INTRODUCTION

This report documents Carolina Power & Light Company's review of operability of the containment purge and vent valves and their ability to close during a design basis accident to assure containment isolation. This review is required by NUREG-0737, II.E.4.2, *Containment Isolation Dependability*.

Operability Qualification of
Purge and Vent. Valves

Plant: Shearon Harris Nuclear Power Plant Unit No. 1

ITEM II.E

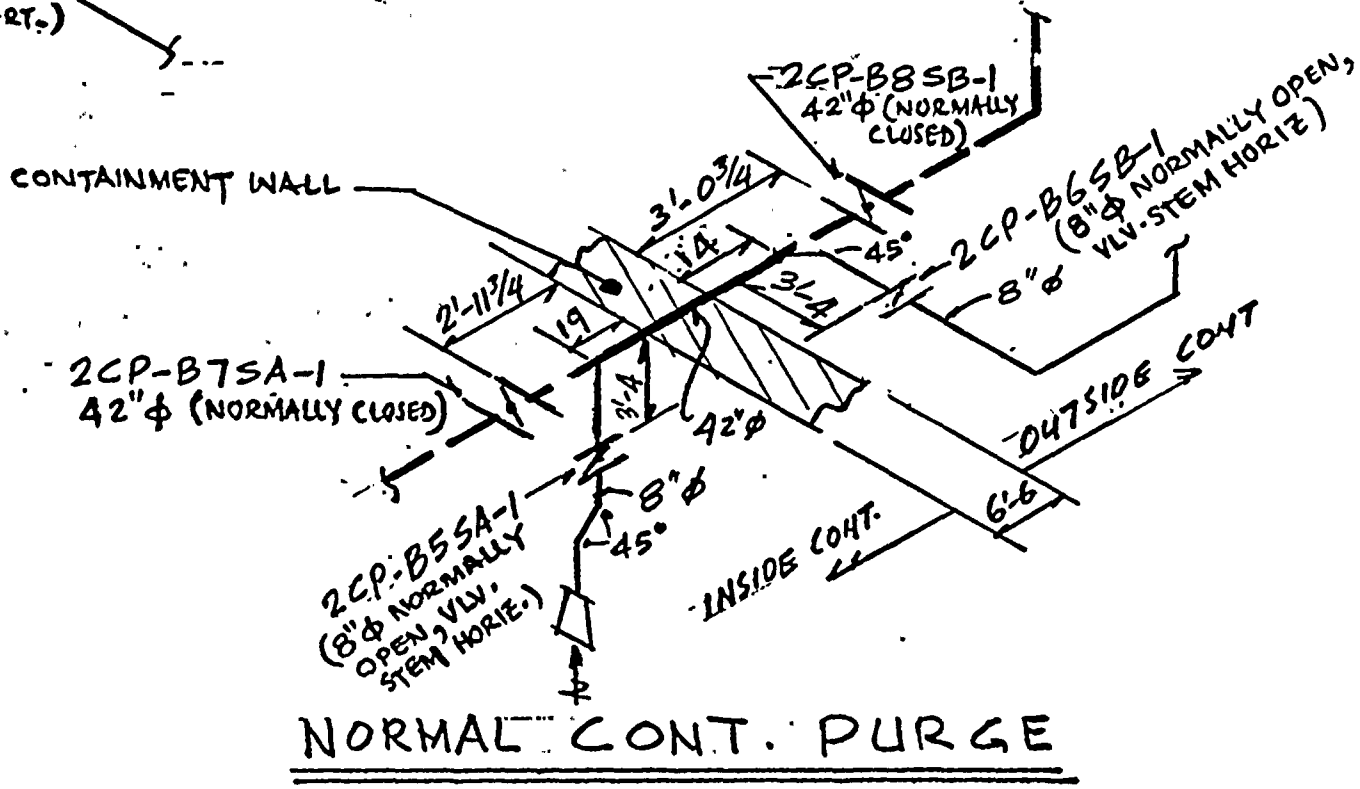
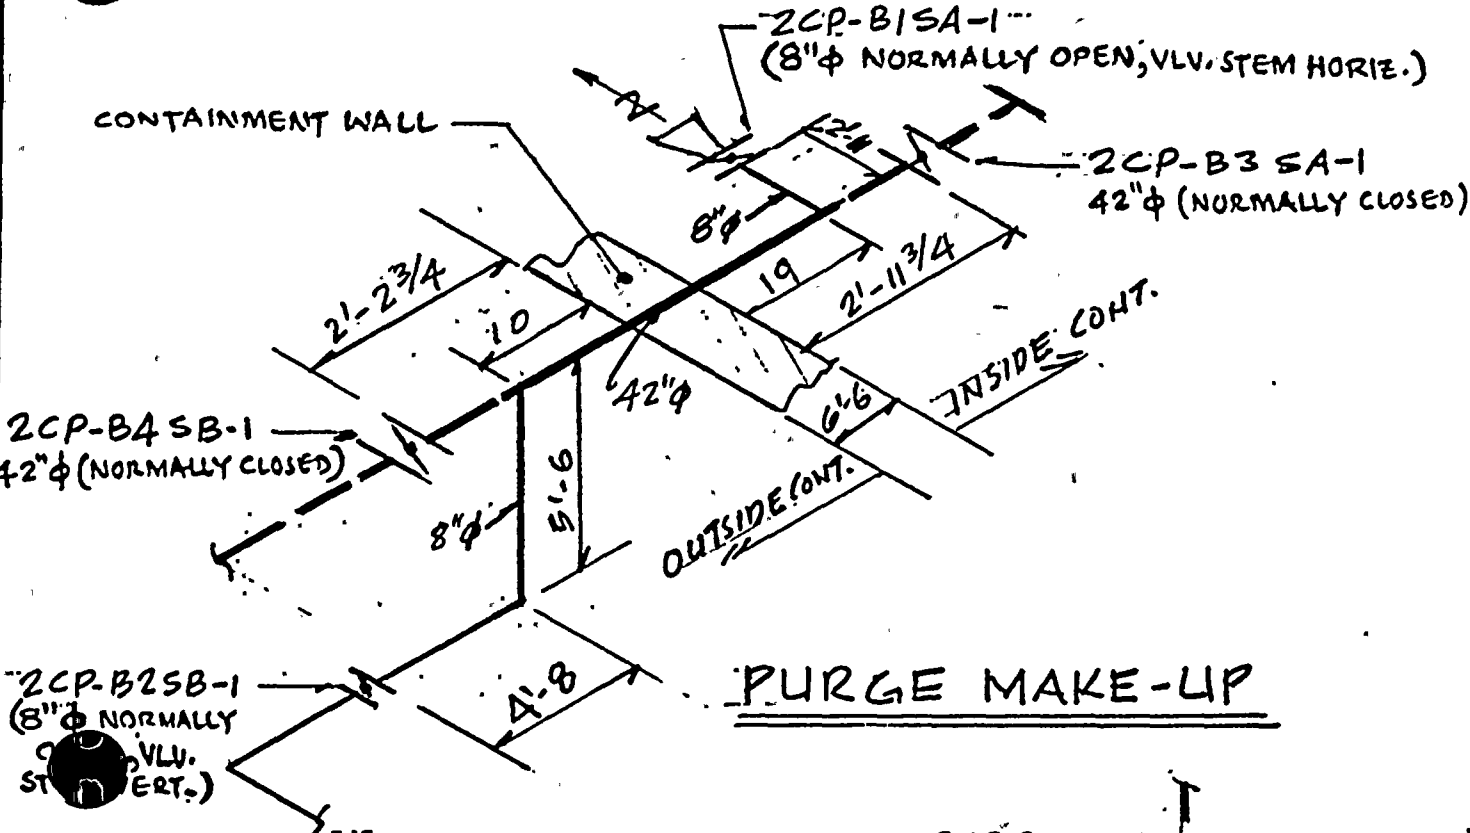
E. Sketch or Description of Valve Installation(s) (Butterfly valves only) showing the following:

- (1) direction of flow; (2) disc closure direction;
- (3) curved side of disc, upstream or downstream (asymmetric discs); (4) orientation and distance of elbows, tees, bends, etc., within 20 pipe diameters

of valve; (5) shaft orientation; (6) distance between valves;

A WORST CASE INSTALLATION IS SHOWN IN THE FIGURE IN ITEM I.E. ON PAGE 38 OF DYNAMIC TORQUE REPORT NO. DT-67926 REV. A. SEE ATTACHMENT C FOR ACTUAL PIPING LAYOUTS IN ISOMETRIC FOR COMPARISON.

Reference(s) THE FIGURE ON PAGE 38 OF THE REPORT DT-67926 REV. A GIVES THE WORST CONDITION COMPARED TO THE ACTUAL PIPING SYSTEM

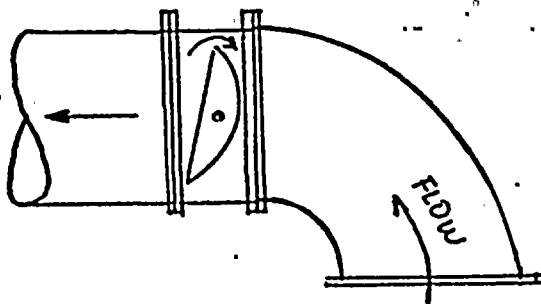
EBASCO COMMENT #1

A point by point response to Items 1.A,B,C,D,E,1,2,3,4,5,6,F,3,4 & 5 of the operability qualification of purge and vent valves and Item 1 thru 8 of Guidelines for Demonstration of Operability of Purge and vent lines are required by EBASCO.

A. Dynamic Torque Coefficient Test Reports are attached.

The report gives the description of the test setup.
